City of Unalaska
UNALASKA LIBRARY
AS-BUILT
 Unalaska, Alaska

DESIGN CLARIFICATION VERIFICATION REQUEST

Unlaska Library

SHEET NO.
A-300

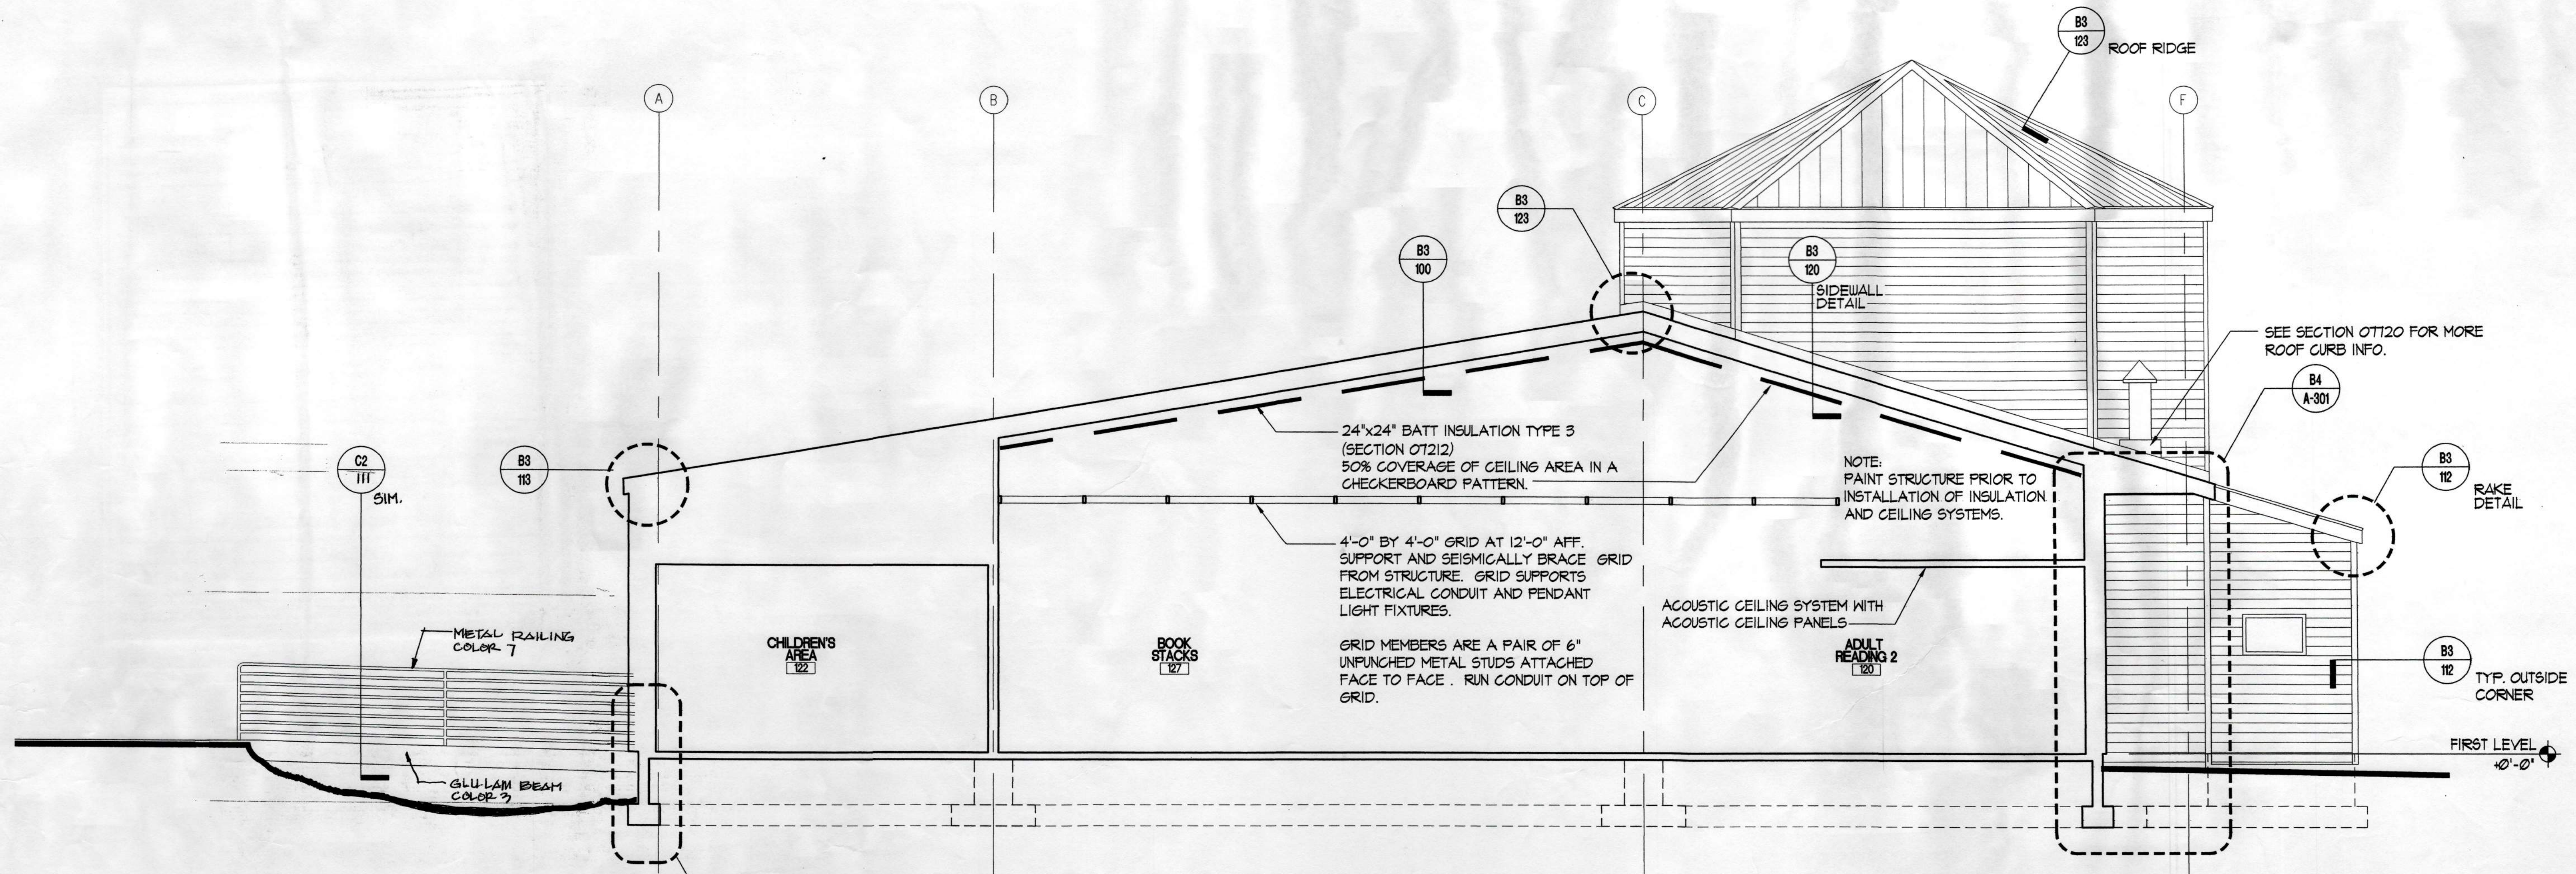
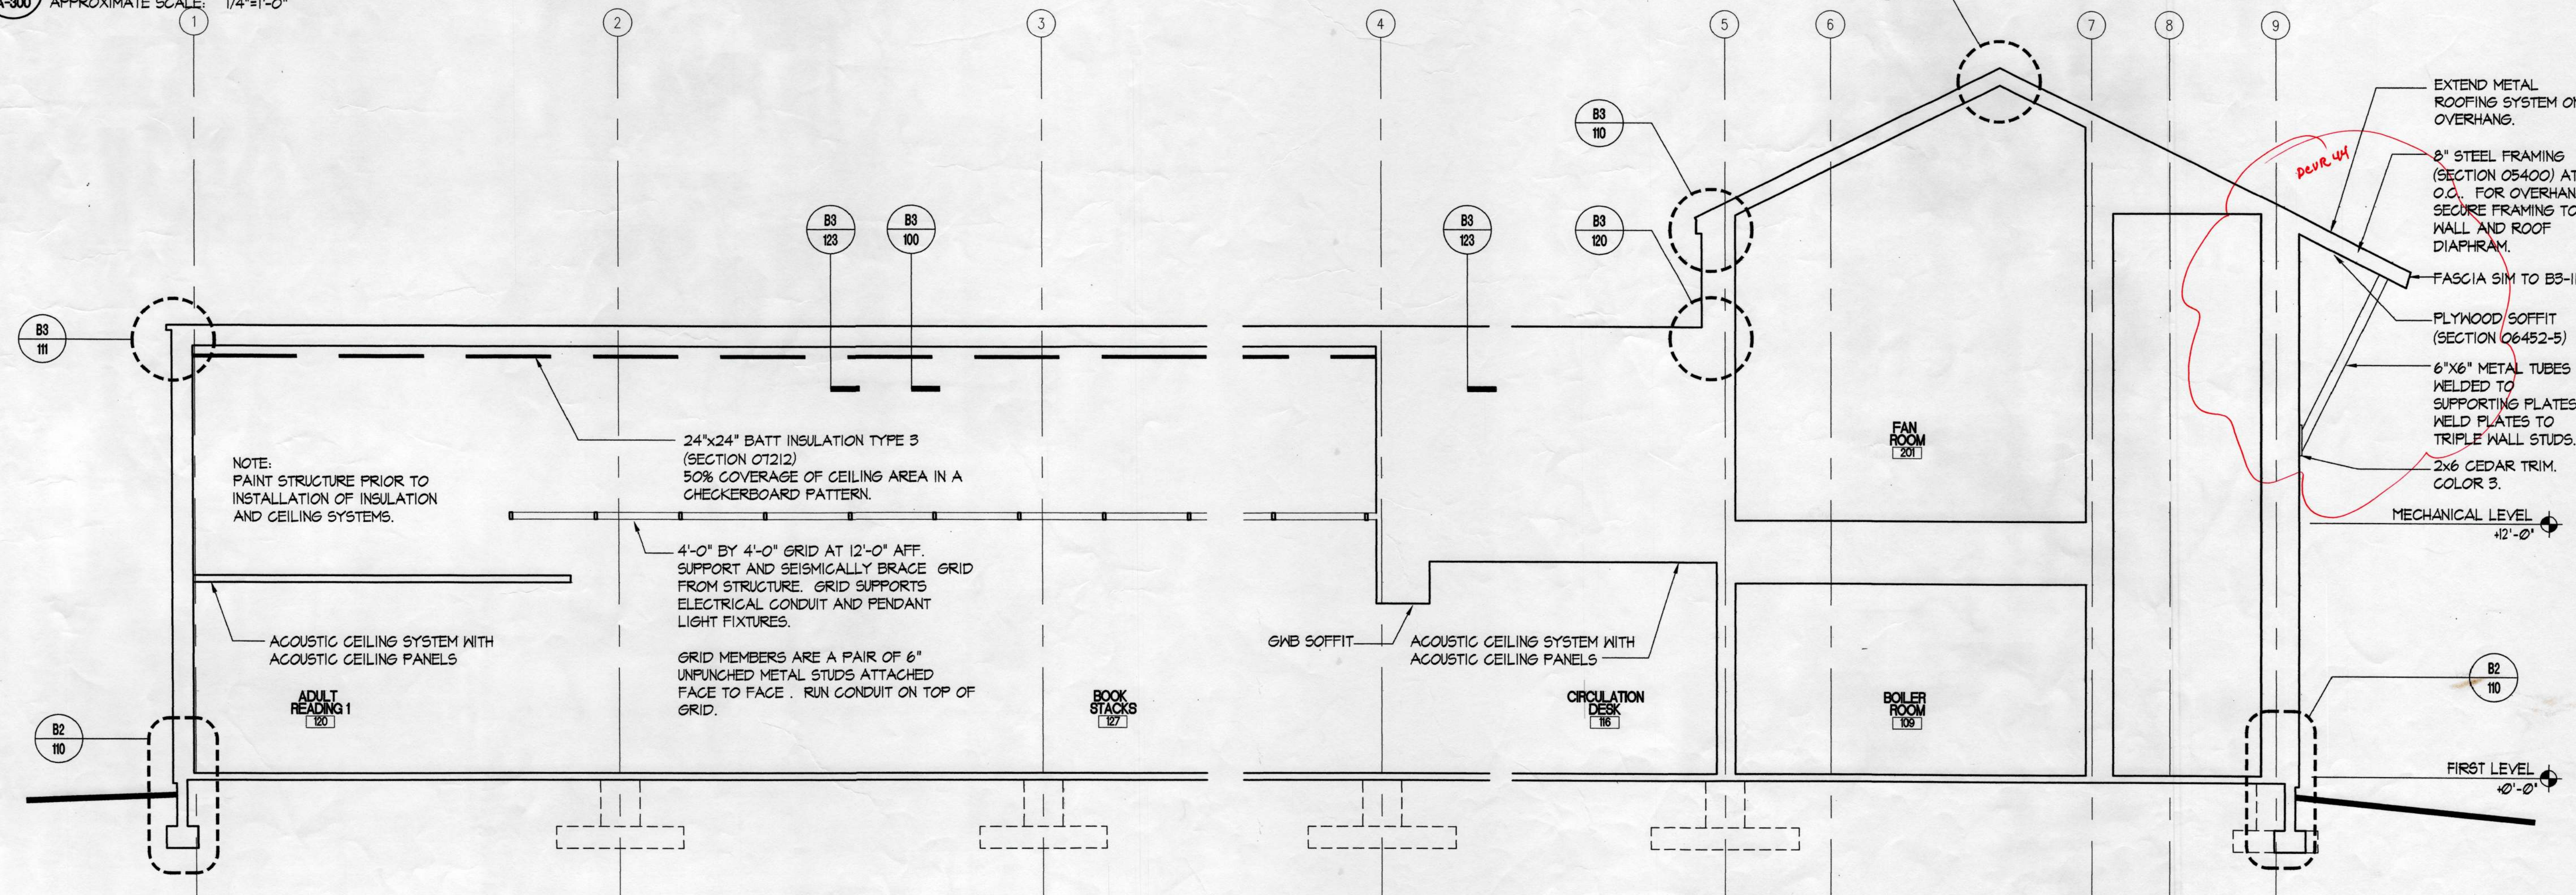
DCVR 44

Each Knee brace shall be fastened with two #12 self-tapping screws to 14ga. studs or blocking (typical at both top and bottom connections of brace). Knee braces can be fastened directly on top of wall sheathing already installed. Refer to attached sketch. 8" steel framing referenced on A1/A500 shall be at 12" o.c. as indicated and may run from knee brace to knee brace or parallel to knee braces at contractors option. Connections of 8" steel framing to knee brace shall be per section 06400. Roof sheathing need not be continuous from main roof to canopy overhang. Roof sheathing and fastening, at canopy overhang, shall be per plywood notes on Sheet S-001.

Note: Plywood soffit, eave and rake details remain unchanged. Coordinate intersection with fascia of main octagon roof to align members of this detail. Ice and Water Shield as well as typical Standing Seam Metal Roofing details apply at canopy overhang.

At lower connection point on knee brace to wall, wrap 4x4 TS with 2x cedar as graphically indicated on elevations sheet A-200. Provide and install flashing and sealant as required at this connection to create a water tight assembly.

SHEET NO.
A-301

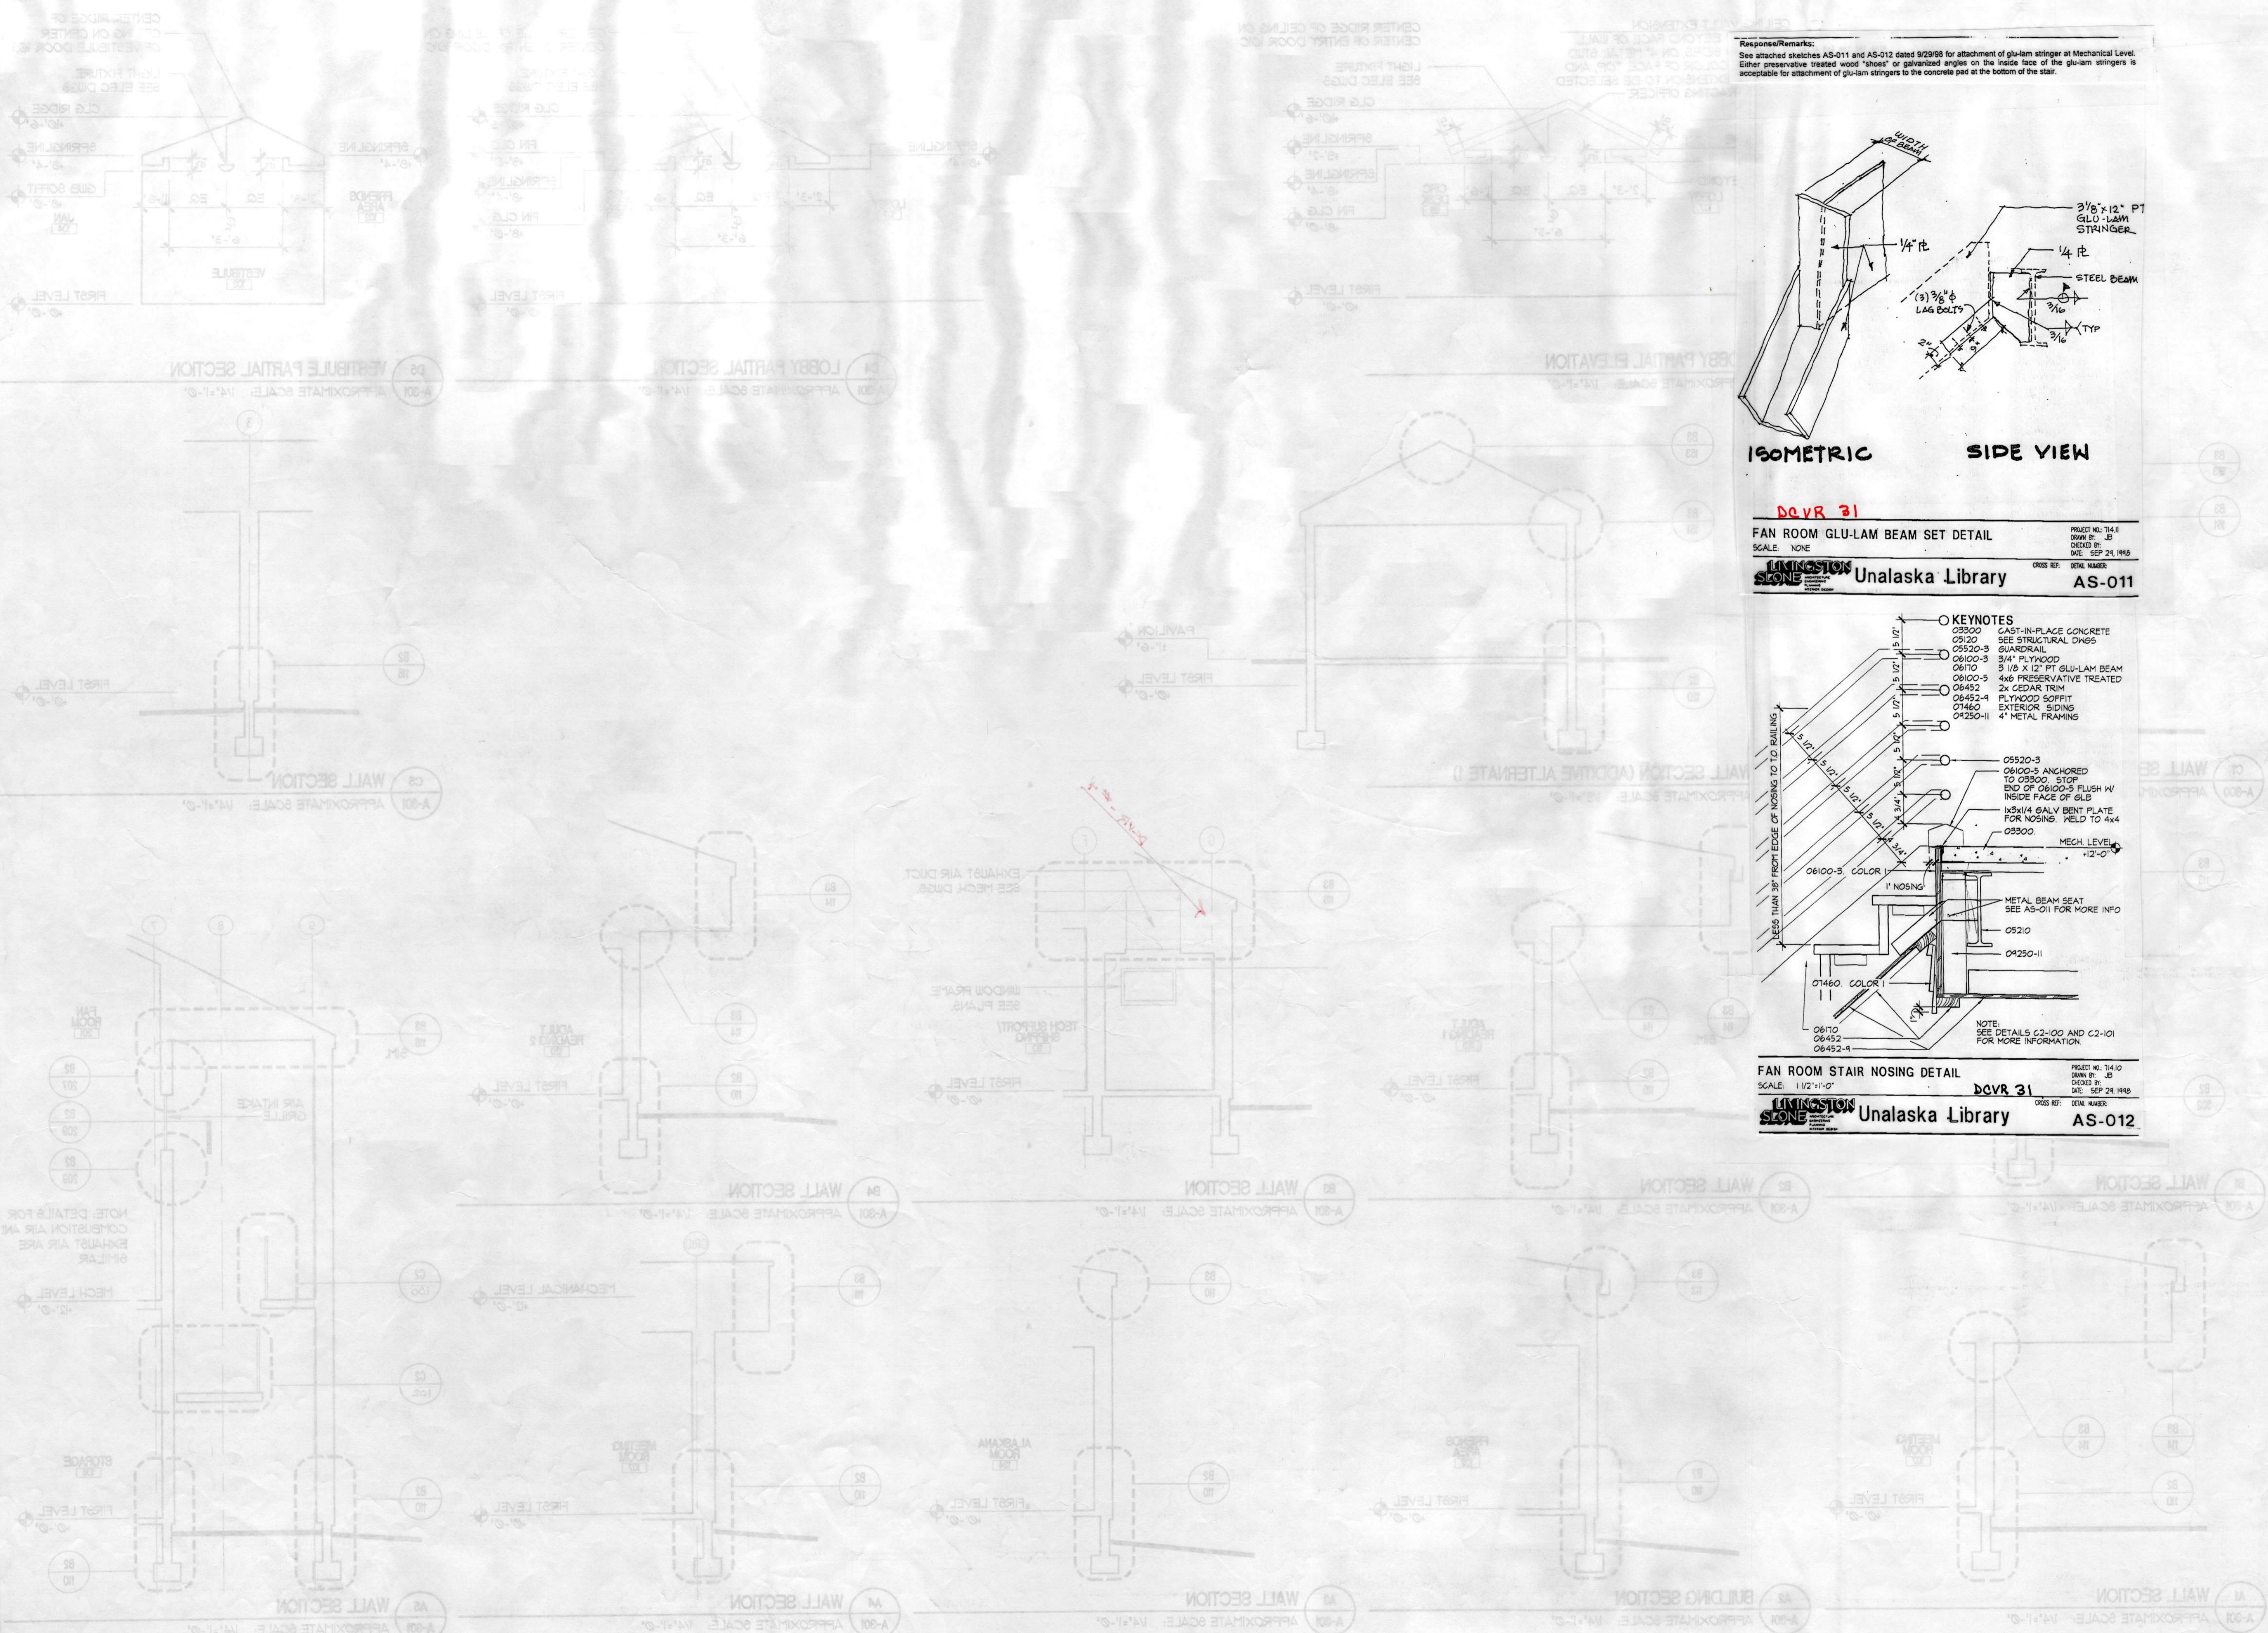
Description: Detail D3/A-301 suggests that the wall studs column line "P" terminates at the ceiling. It appears like the wall along "P" line should run past the roof line at the 1st floor and terminate at the 2nd floor roof. The low roof should be into the wall along "P" line instead of the wall into the roof.
 Please Advise.

Response/Remarks: JOD No: 22/2
 DCVR #4 FILE: D TO D 11
 Metal framing can be revised per your recommendation. If the framing is revised, relocate the vapor retarder to be it is continuous for the underside of the roof deck to the interior face of the exterior wall. Seal the vapor retarder to the underside of the roof deck. All mechanical, electrical and plumbing penetrations through the vapor retarder must be sealed. CC: JG, EF, GB
